SPRINGHILL PLACE SUBDIVISION

The plat illustrates the proposed 2.8± acre, 8-lot subdivision located at the Northwest corner of Bishop Lane North and Broadway Drive. The site is served by public water and sanitary sewer.

The purpose of the application is the creation of an eight-lot private street subdivision from a metes and bounds parcel. The plat also illustrates reduced setbacks for one lot. Subdivision applications that include private streets and reduced setbacks are required to be accompanied by a Planned Unit Development (PUD) application, if the site is located in the city. The applicant had submitted an application for an Administrative PUD, but this was not accepted, since it involves multiple dwellings and the creation of a new private street; the applicant was informed at that time that a full PUD application was required to accompany the subdivision application.

DETAIL SITE PLAN

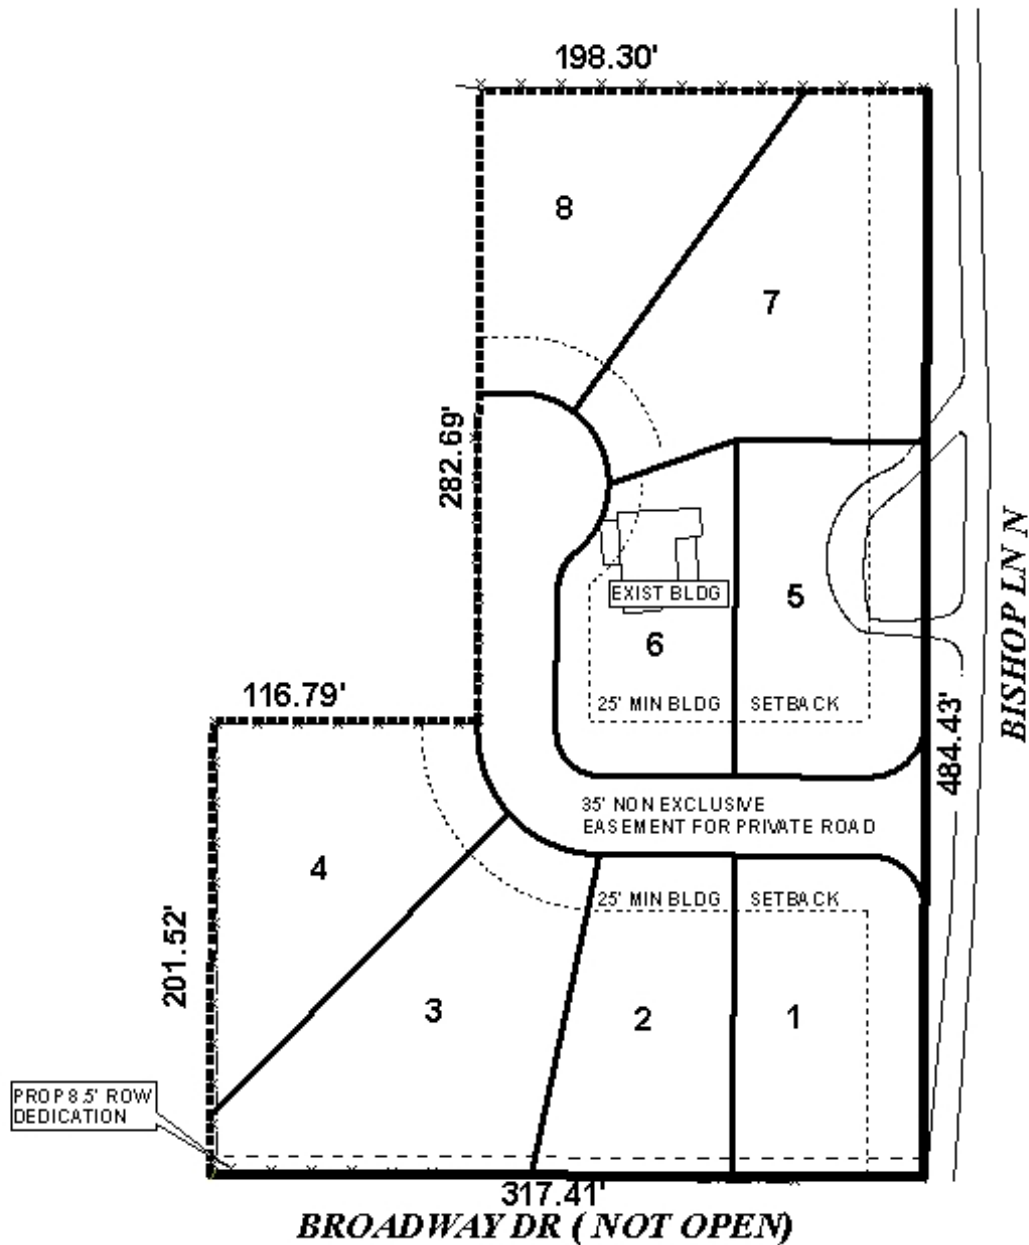
The site fronts Bishop Lane North, with a 50' right-of-way, and Broadway Drive, which is not open at the site, and the right-of-way of which varies from 33 feet to 41.5'. As this is substandard in width, dedication of sufficient right-of-way to provide 25 feet from the centerline of Broadway Drive would be required.

The proposed new street is labeled a "35' non-exclusive ingress/egress easement for private road". However, an easement is not acceptable; there must be private street right-of-way. Additionally, Section VIII.E.2(c) of the Subdivision Regulations requires private streets with two lanes to have a minimum right-of-way of 50 feet and a minimum pavement width of 18 feet with four feet of paved wings. Section VIII of the Subdivision Regulations permits modifications to standard regulatory circumstances, where the normal application of the Regulations would cause undue hardship; 2) Innovative design, which can include cluster or Traditional Neighborhood Development subdivisions, as well as townhomes, terrace houses, multi-family projects, and commercial development; or 3) Family subdivisions, which allow a private street to served up to

The required 25' building setback lines are shown along the existing streets and for most lots along the proposed street; however, proposed Lot 6 is shown with a 15' setback line, and with an existing building that extends to the front property line.

It should be noted that, with the prescribed street width of 50 feet, the existing building would be within the right-of-way; even with the substandard 35' proposed width, the building would encroach on the required building setback of 25 feet, or even on the proposed 15' setback. Thus, to accomplish the subdivision with the minimum standards of the Subdivision Regulations, the existing structure would have to be removed or relocated.

The plat also shows a substandard turnaround with a flat side abutting the adjacent property. There is no indication whether this is a temporary turnaround intended to extend into the western parcel not included in this subdivision. If continuation of the street into the adjacent parcel is not planned, the turnaround should be reconfigured as a permanent turnaround of standard dimensions.

An existing semicircular asphalt drive with two curb cuts onto Bishop Lane North is shown for proposed Lot 5 and a portion of proposed Lot 7. As a means of access management, Lots 1, 5, and 7 should be denied access to Bishop Lane North, and the removal of the asphalt drive should be required; also, Lots 1 through 3 should be denied access to Broadway Drive.

Based on the preceding, a holdover is recommended to allow the applicant to submit a full Planned Unit Development application; documentation of unusual difficulty or circumstances, or of innovative design; and a revised plat illustrating compliance with private street standards, turnaround standards, and setbacks. These documents should be submitted by June 13 for the July 7 meeting.
